SUBJECT: Proposes mod to turbine runback sys, deleting flux rat input.
 Sys prone to spurious runbacks due to single failure of
 single electrical component. Encl safety evaluation discusses
 consequences of single dropped rod control cluster assembly.

Re: Turkey Point Units 3 & 4
Docket No. 50-250 and 50-251
Turbine Runback System

MODIFICATION OF THE TURBINE RUNBACK SYSTEM

FIGURE 1

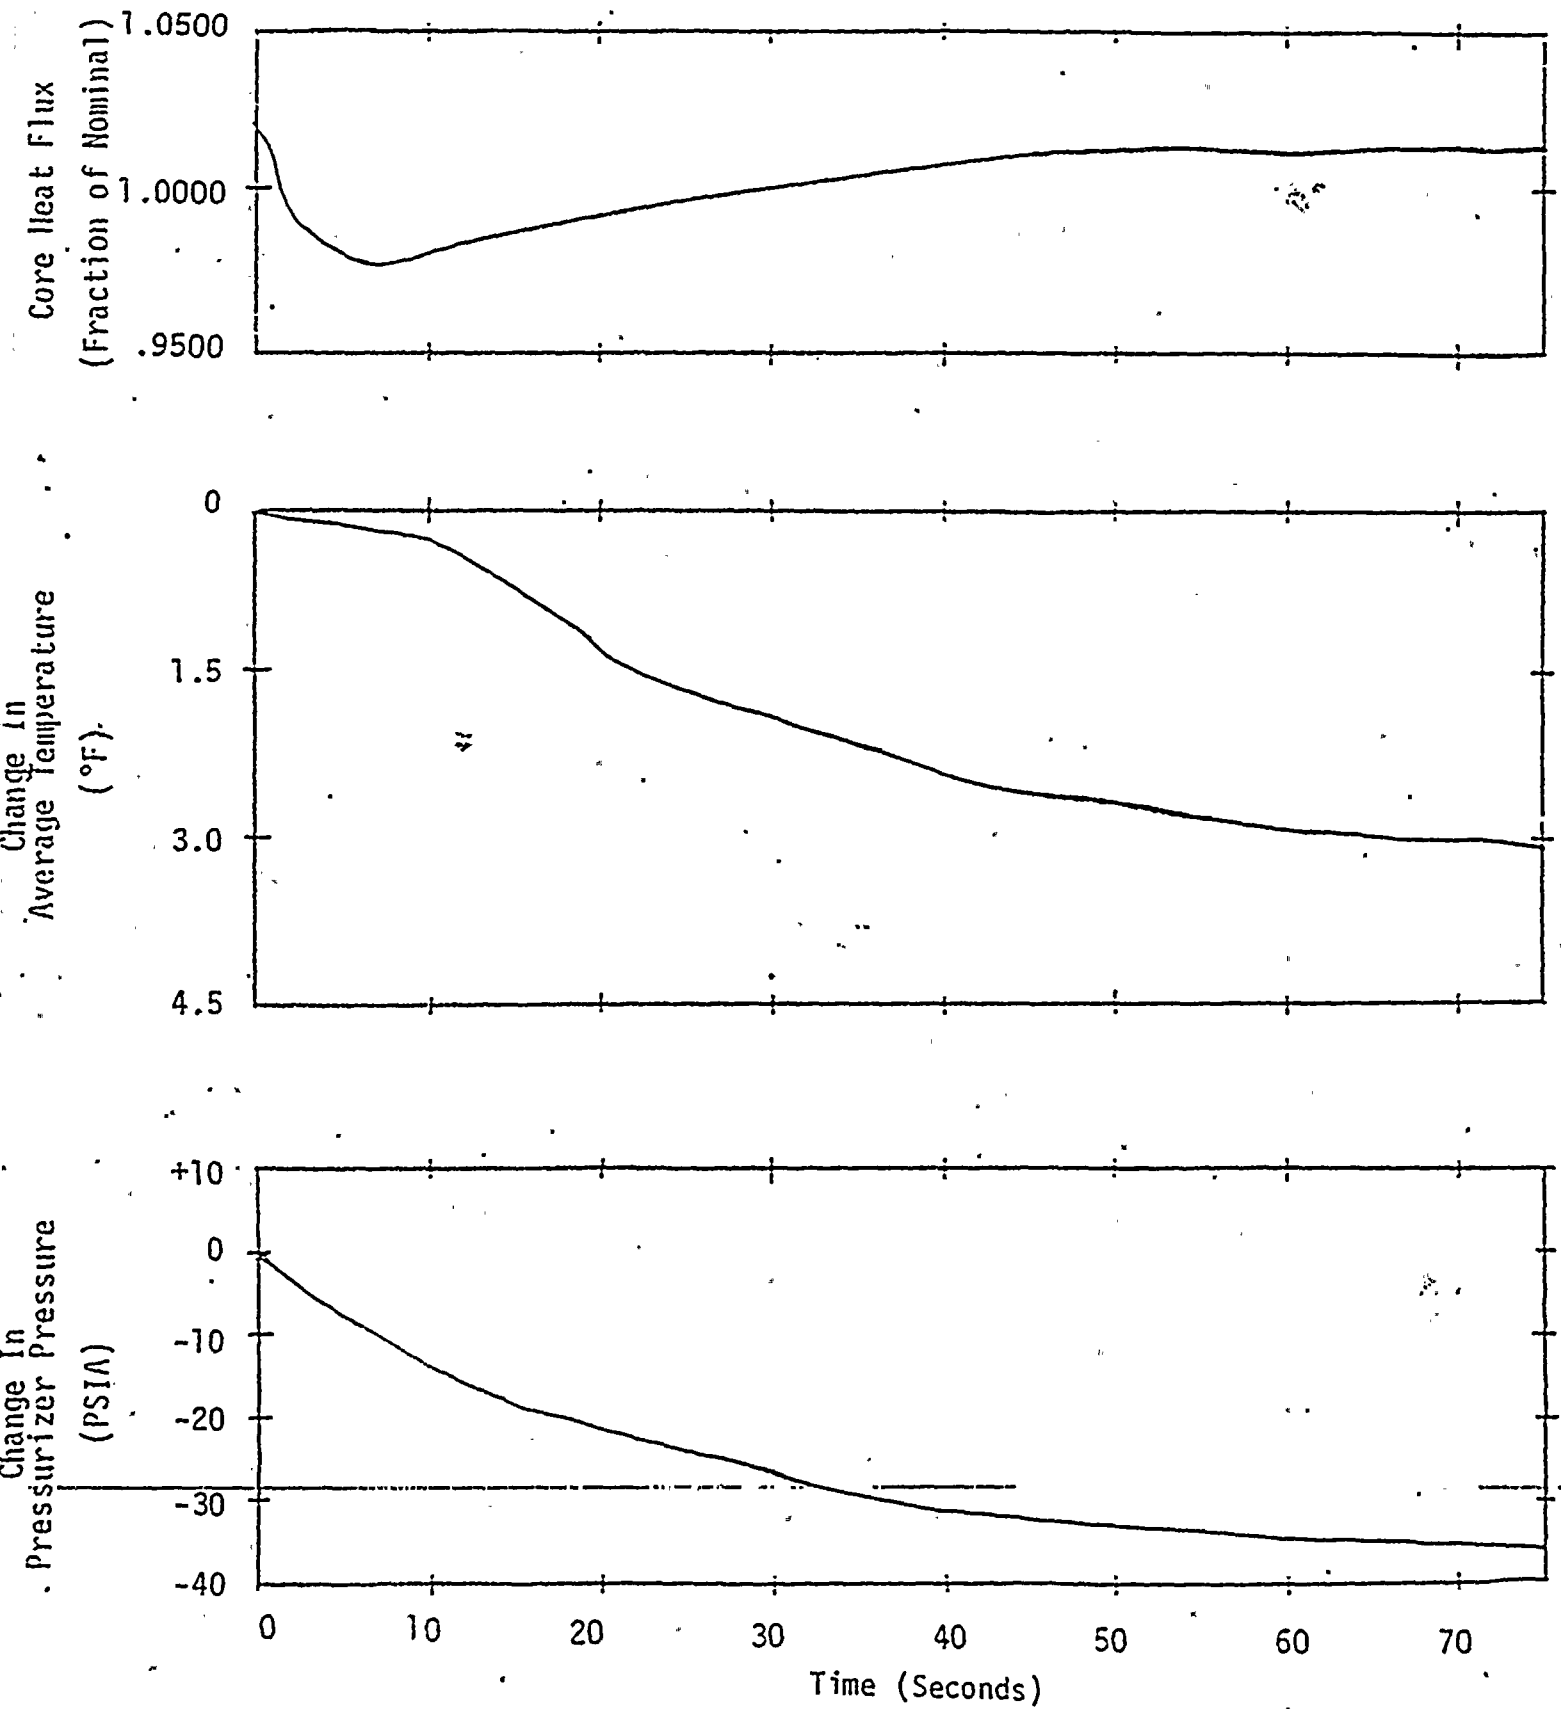
Figure 1 illustrates the transient for a typical dropped rod worth of 150 pcm in manual rod control. The core heat flux initially drops and then returns to the initial power level due to reactivity feedback. Temperature and pressure drop to a lower value. New equilibrium conditions are reached with the core at full power and reduced temperature and pressure. These conditions are less limiting than those for which the static full length misalignment of an RCCA is analyzed in the Reload Safety Evaluation for each cycle. In this analysis, the reactor is at full power with nominal temperature and pressure (including uncertainties). At the same power level, the DNBR benefit due to the reduction in temperature which occurs in the transient case more than compensates for the DNBR penalty caused by the transient drop in pressure. Thus, the single dropped RCCA analysis assuming manual rod control and no turbine runback is bounded by static RCCA misalignment. A dropped RCCA in automatic rod control is not bounded by this analysis since a power overshoot above 102% could occur.

In summary, Westinghouse finds that it is acceptable to delete the flux rate portion of the turbine runback system provided the plants remain in manual rod control. The detection and analysis of dropped banks are not affected by this change. A dropped RCCA which does not result in a runback is bounded by static RCCA misalignment.
